## **OXFORDSHIRE COUNTY COUNCIL'S RESPONSE TO CONSULTATION ON THE FOLLOWING DEVELOPMENT PROPOSAL**

**Application no:** 21/02286/F

**Proposal:** Construction of a coffee unit with drive-thru facility and indoor seating with associated access, car parking, landscaping and servicing parking

**Location:** Land North West Of Launton Road Roundabout Adjoining, Skimmingdish Lane, Caversfield

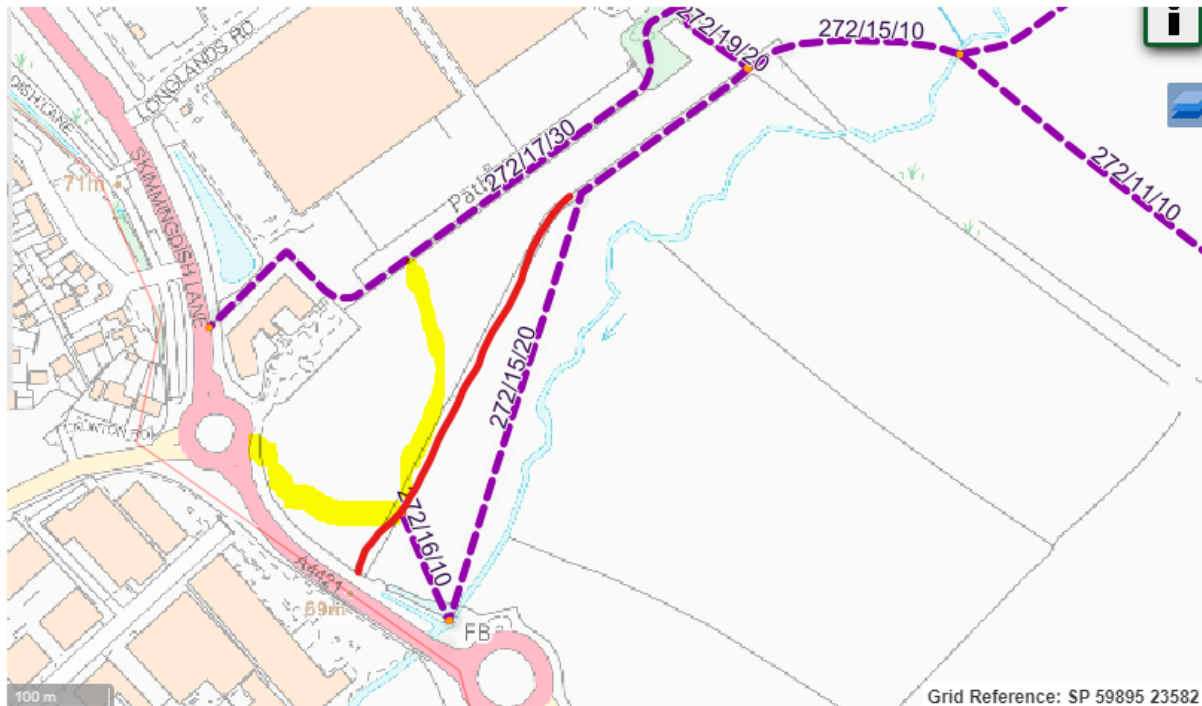
A total of three covered Sheffield stands will be provided in total six spaces for staff and customers. In my view this should be doubled as a minimum to encourage active travel by patrons.

The current location of the cycle parking within the car park could be a deterrent for cyclists (especially staff members who maybe leaving their bicycles for a significant period) - a) it is situated at the furthest edge of the car park, a fair distance from the main building and, b) is not in a visible location and so the security of the bikes may become an issue. It is therefore recommended for the cycle parking to be moved closer to the main building.

Regarding the drive-thru development, it is noted the redline extends to the farm track. It would therefore be good to get a connection for footpath 272/16 through the site just so it does not dead end. Two suggested alignments are shown on the map below. Although officially a dead end, walkers regularly red line. To prevent this, it would be good to see this dedicated as a PROW, which would include some clearance and surfacing works,
